Parts Technical Information

P.T.I.: 161

MODELS: XJS range
XJ6 range

SUBJECT: Steering Racks

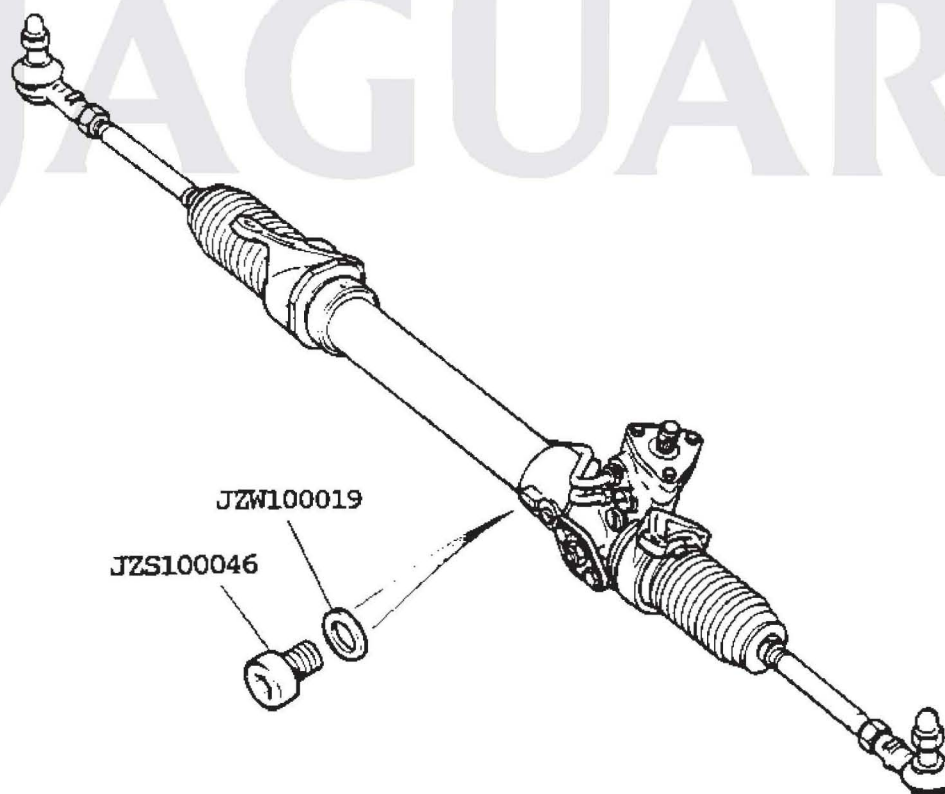
Page 1 on P.T.I. No. 160 issue 2 showed an incorrect Part Number **JZS 100019** for the Washer. The correct Part Number is **JZW 100019** and is shown below.

SUBJECT: Steering Racks

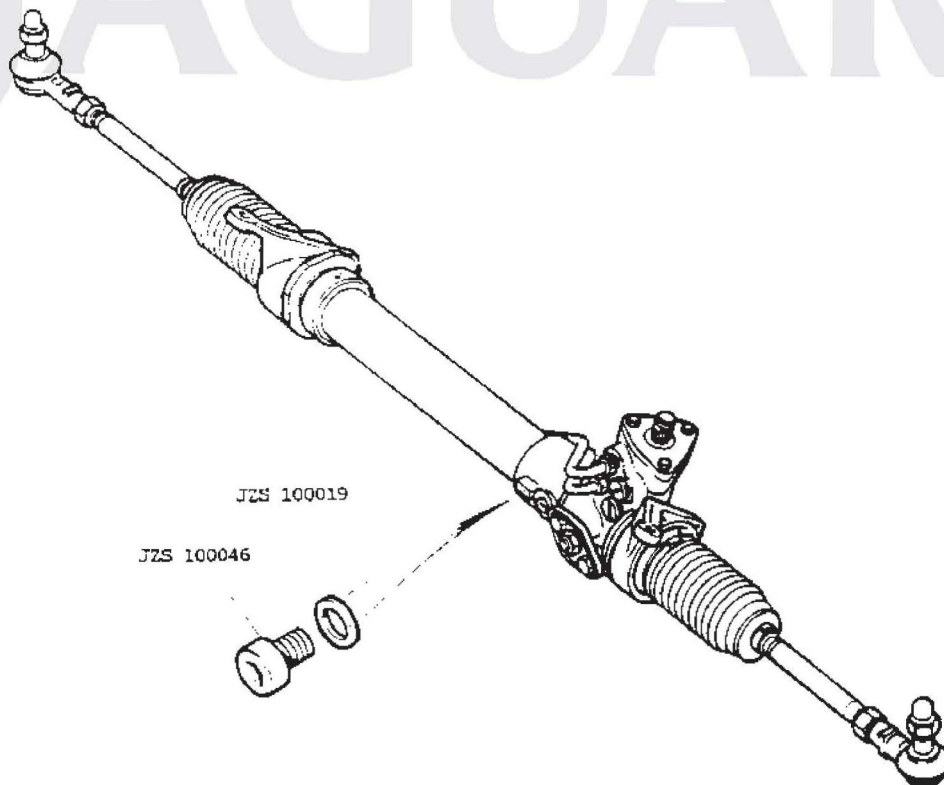
A recent change of Steering Rack manufacturer has taken place. The new Racks are visually different from the old, but are fully interchangeable.

The new type parts will be supplied when stocks of the old are exhausted as per the charts on the following page; any original equipment part number not mentioned on the following lists will continue to be supplied until further notice.

N.B. When ordering the above range of Steering Racks the following additional parts will be required.

JZS 100046 x 1 Screw
JZW 100019 x 1 Washer

To replace Centralising tool supplied with Rack.

SUBJECT: Gauge, Fuel Tank Unit

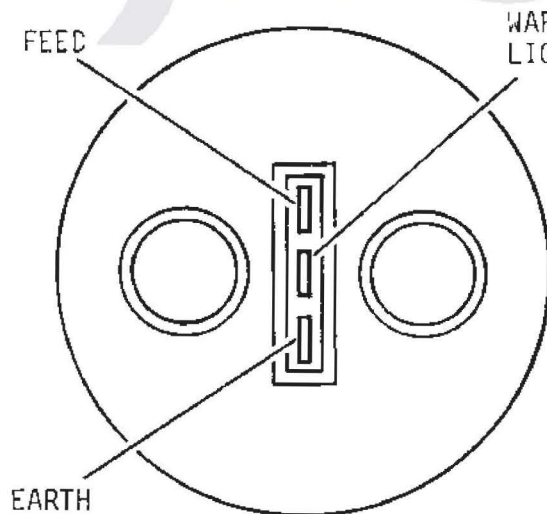
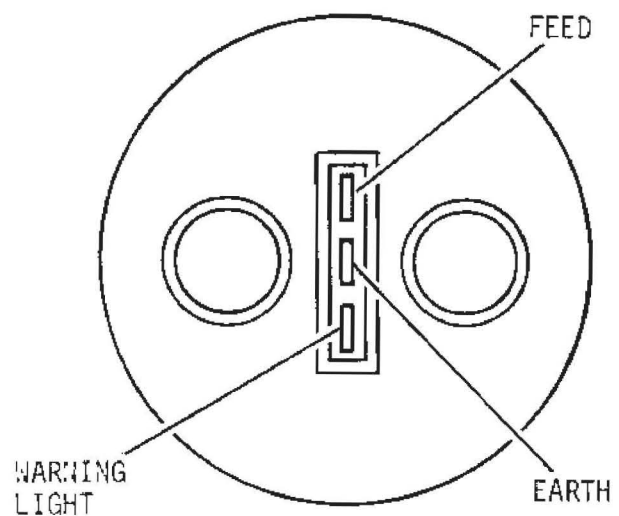
Suppliers of the original equipment fuel gauge, DAC 6103 are no longer available. A new unit, DAC 10183 is introduced with different positions for the warning light and earth terminals. Detailed below are the two conditions with the respective terminators.
